Permit Number: 081352

has permission to Commercial "Tim Horton's" - New signage "Tim Hortons"

AT 1412 CONGRESS ST

Dept: Zoning **Status:** Approved with Conditions **Reviewer:** Marge Schmuckal **Approval Date:** 10/30/2008

SIGN#1

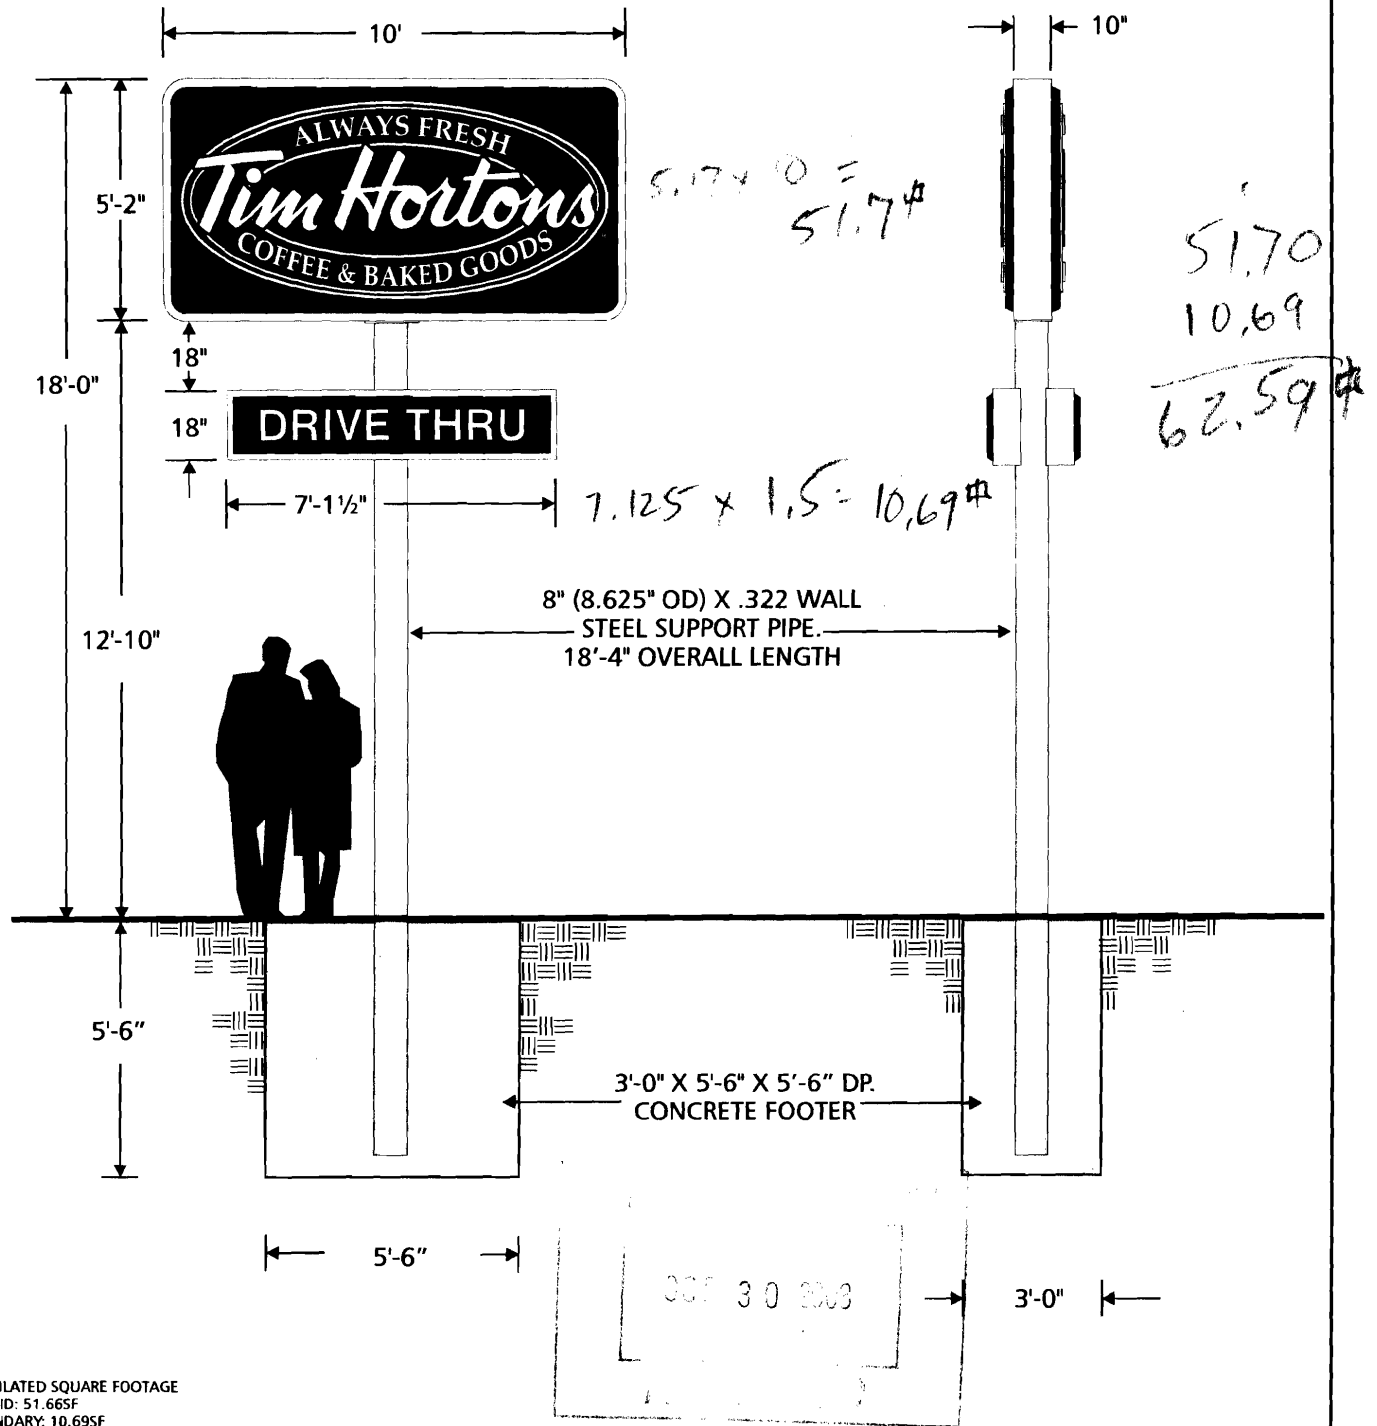
10/29/2008-mes: called the sign company, John Gavin. No information on the free standing sign is included for review - what is "translite cell" material that is shown on several of the signs?

Free Stand Sign s.d.
65 \$ MAX - 62.59
18' high MAX - 185 \$
5' set back min - 5 \$
OK

Permitted (1) Sign @ 65sf, 18' max overall height, 5' setback.

10/30/2008-mes: John G. sent me an e-mail showing the specs for the free standing sign.

SIGN#2 @ Front Elevation facing Congress Street.
Permitted 2sf/building frontage.

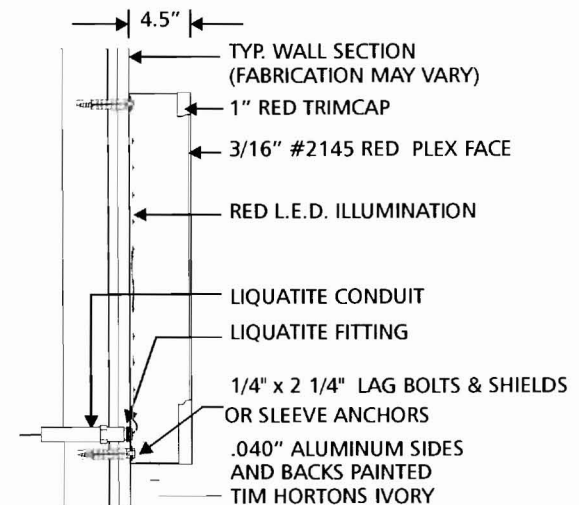
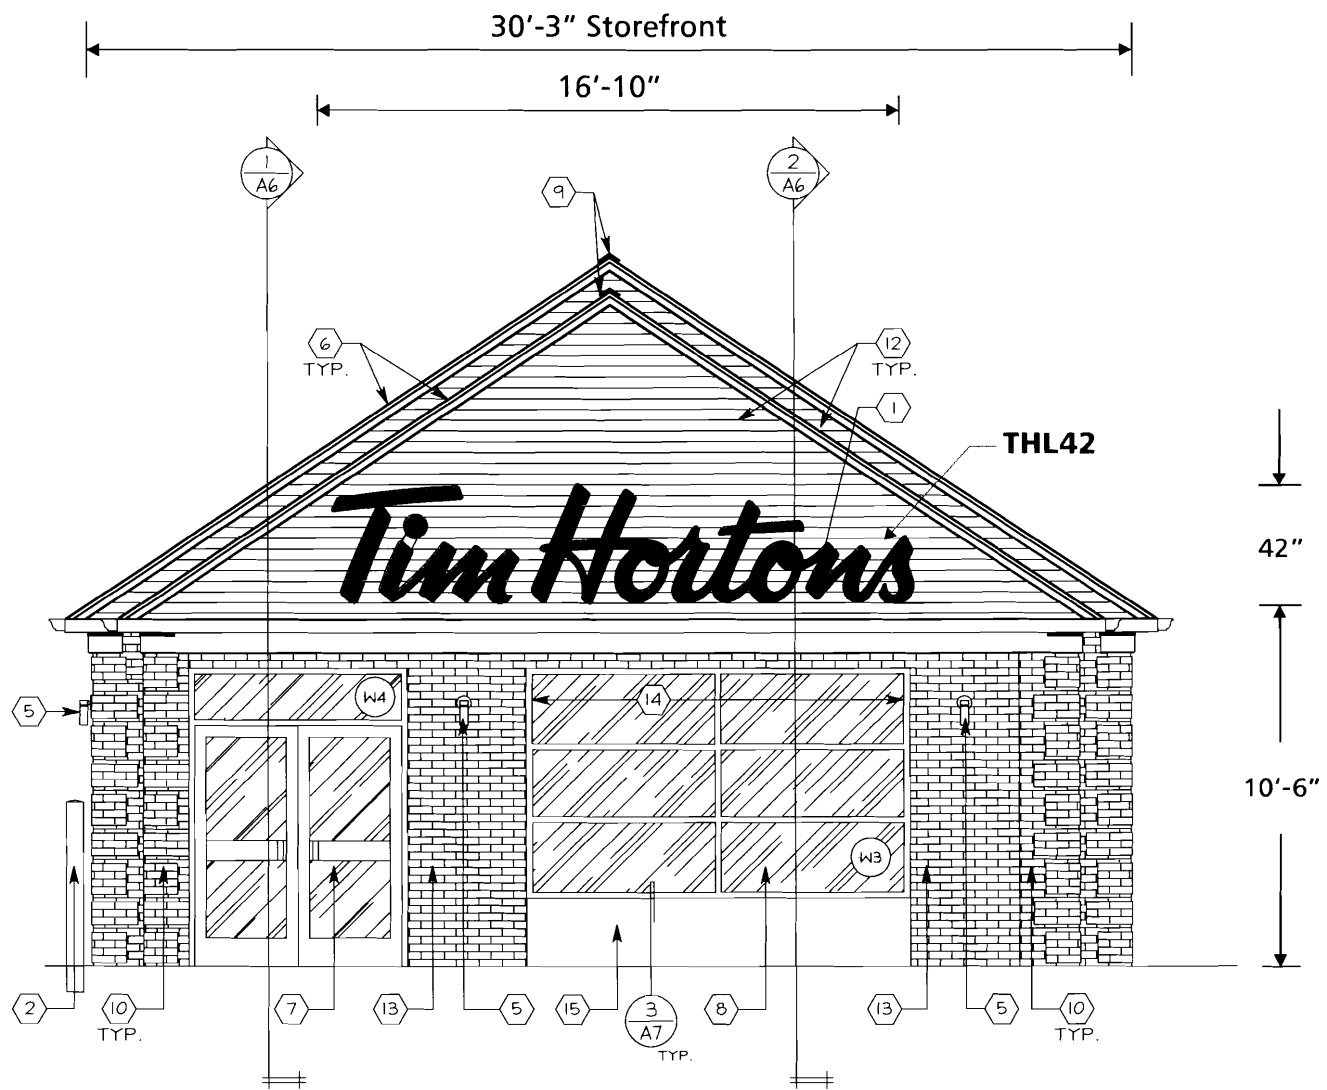
$3.5 \times 16.83 = 58.905 \text{ sf}$

1 per Bldg facade but not more than 150^{sf}
